## 30-045-35145 SIXTEEN G'S COM #091S DUGAN PRODUCTION CORP

#### **Planned Wellbore Schematic**

Re: Permanent Abandonment Well: Sixteen G's Com #91S

#### **CONDITIONS OF APPROVAL**

#### **Current Wellbore Schematic**

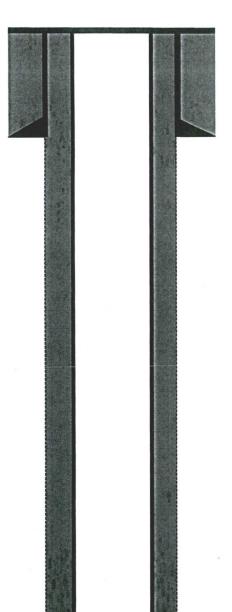
Application Type:  P&A Drilling/Cas	sing Change Location Change
	hydraulic fracturing operations review EPA dance #84; Submit Gas Capture Plan form prior to operations)
Other:	
Conditions of Approval:	
<ul> <li>Notify NMOCD 24hrs prior to beg</li> <li>Extend Plug #1 1690'-835' to cove 885'</li> </ul>	ginning operations.  er the Ojo Alamo top. OCD Ojo Alamo pick @
Katheric Park	3/15/19
NMOCD Approved by Signature	Date
